PUBLIC UTILITIES COMMISSION

Subject: Atascadero - San Luis Obispo 70kV Power Line Reconductoring Project
Variance Request #16

Attachment A: Variance Request #16

Atascadero – San Luis Obispo 70 kV Power Line Reconductoring Project

EWS Map and Photos

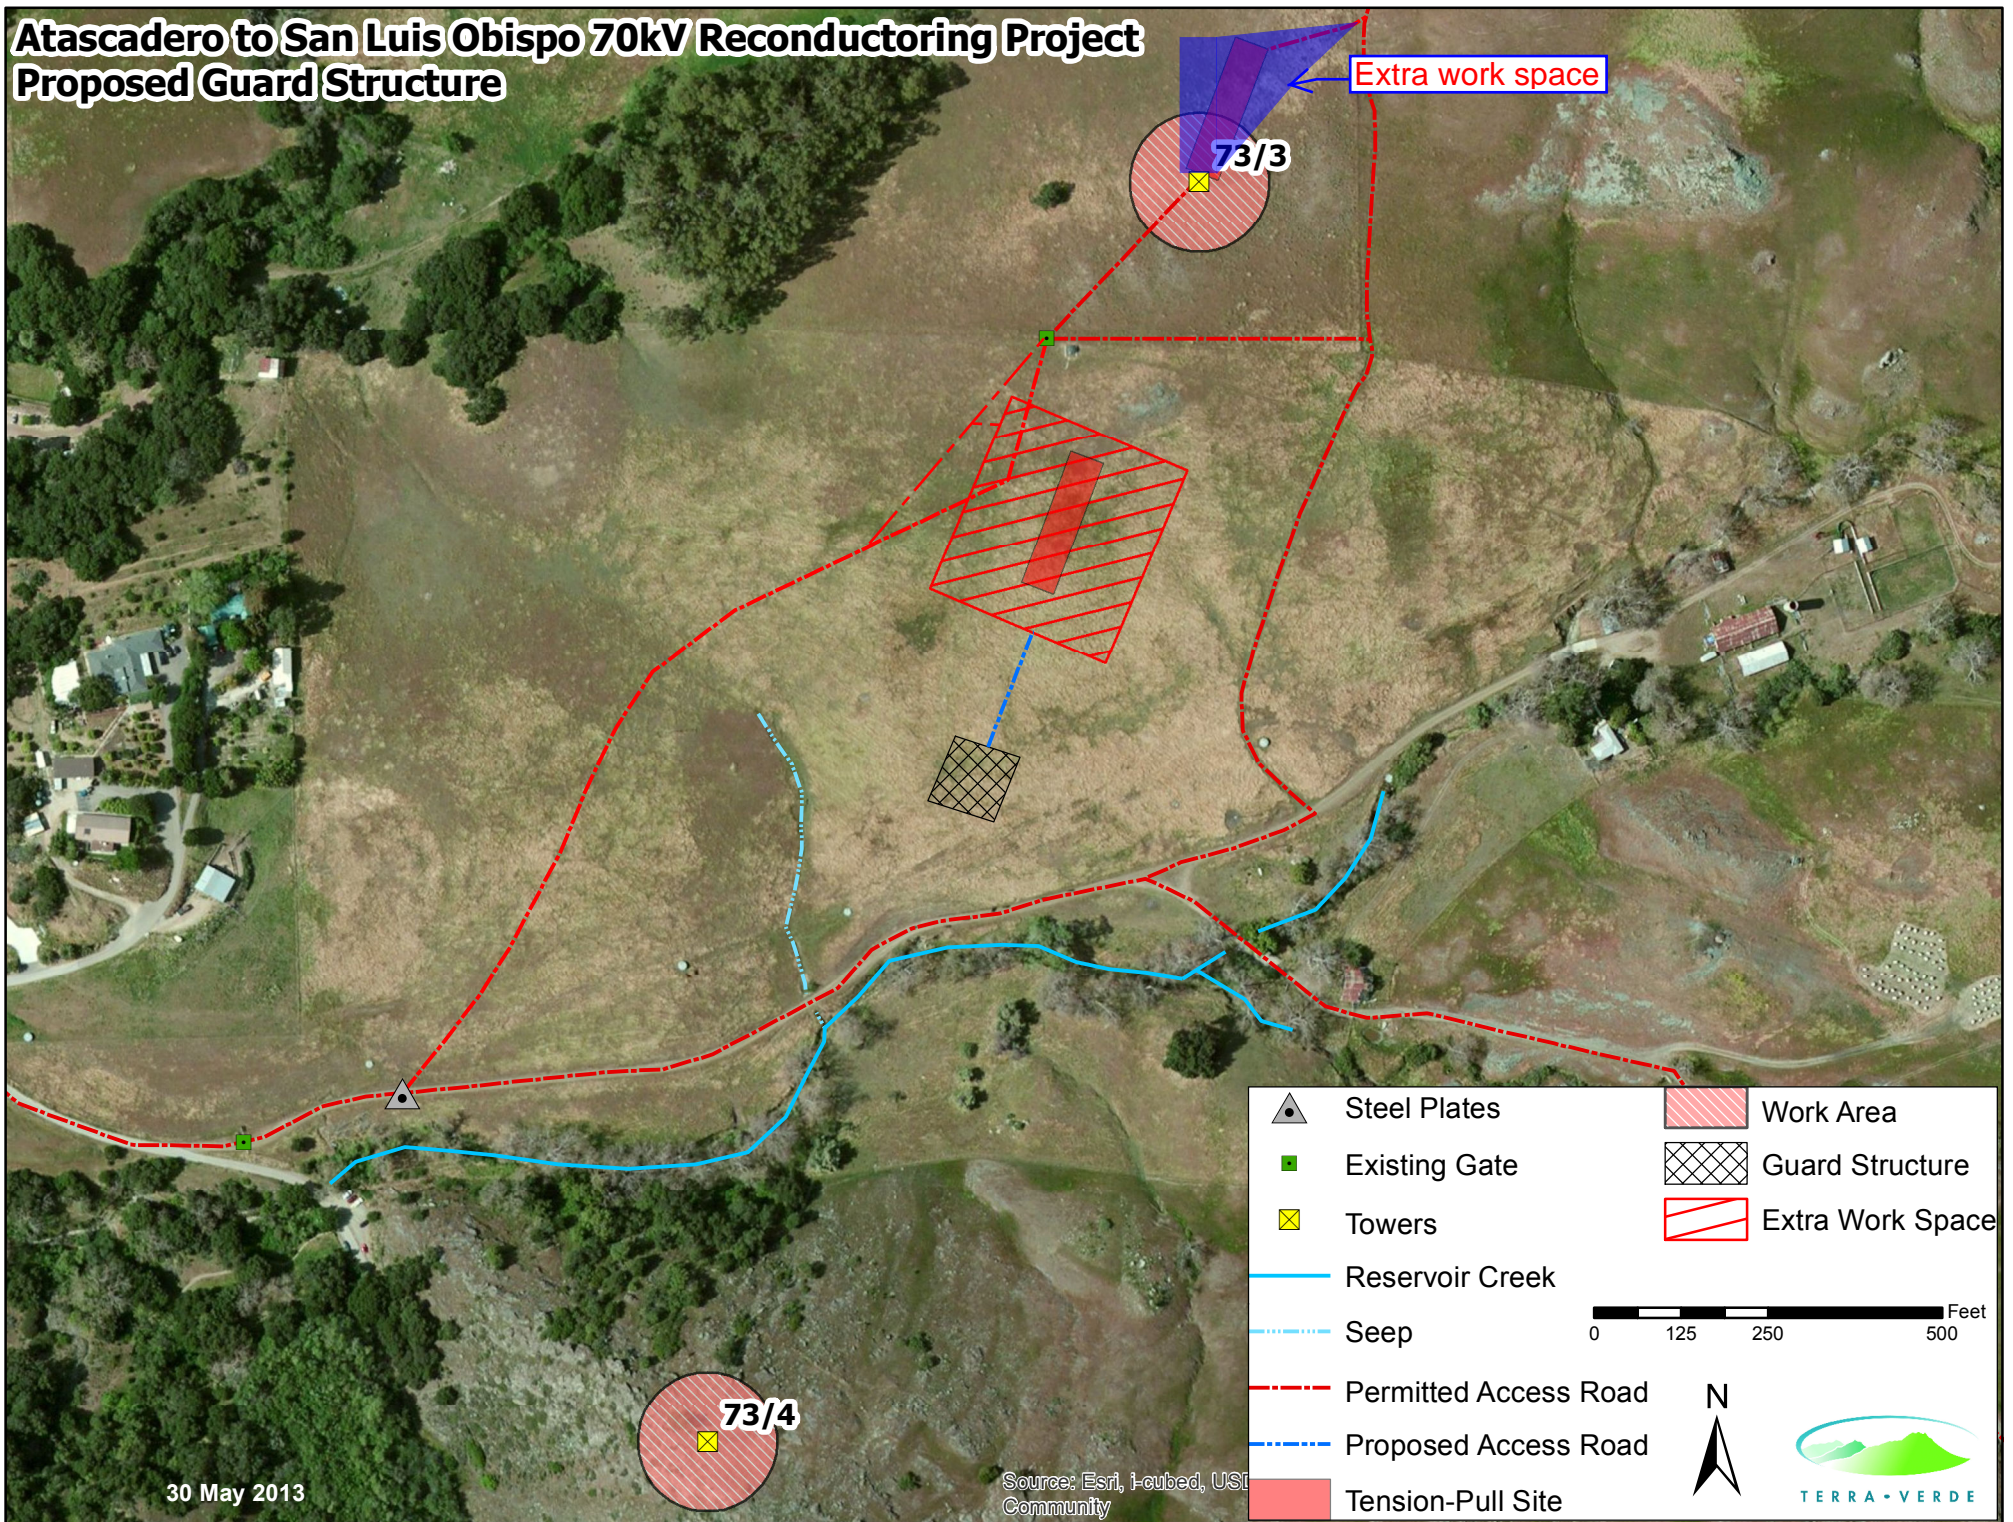
PG&E has requested the use of an additional area adjacent to Tower 73/3 for reconductoring of the steel tower section. Tower 73/3 currently has two approved pull/tension sites, however due to the orientation of the overhead conductors at that location coupled with the necessary space and topography required for equipment operation, the additional extra workspace is being requested. The additional pull/tension site is requested for the Tower 73/3 to SLO substation pull.

The additional workspace is shown in blue on the attached map. The workspace is heavily grazed annual grassland with patches of sparsely scattered California sagebrush (*Artemisia californica*). Project activities are not expected to impact California sagebrush shrubs. The workspace is triangular shaped in order to allow access for the reel truck which will need to back down to the tower from the access road.

The extra workspace is requested because the originally mapped area for the 73/3 TPS is directly under the conductors. Per PG&E, the equipment needed to pull from 73/3 to SLO substation must be offset from under the alignment. Due to topography, shifting to the NW is most

desirable. Additionally, access was requested from above (farther north) to allow a truck to back down the hill with the reels.

The CPUC has determined expanding the pull-and-tension site (PTS) north of Tower 73/3 would not create greater environmental impacts or new significant impacts than those analyzed in the approved Final Initial Study/Mitigated Negative Declaration (IS/MND) for the project. A description of PG&E's proposed actions and an analysis and these findings is presented below.

CPUC staff finds the changes proposed in PG&E's Variance Request #16 are not substantial, would not result in new or significantly greater impacts to the environment, and do not present new substantial information that would change the findings presented in the IS/MND. The Variance is consistent with the IS/MND and no additional CEQA analysis or decisions are required.
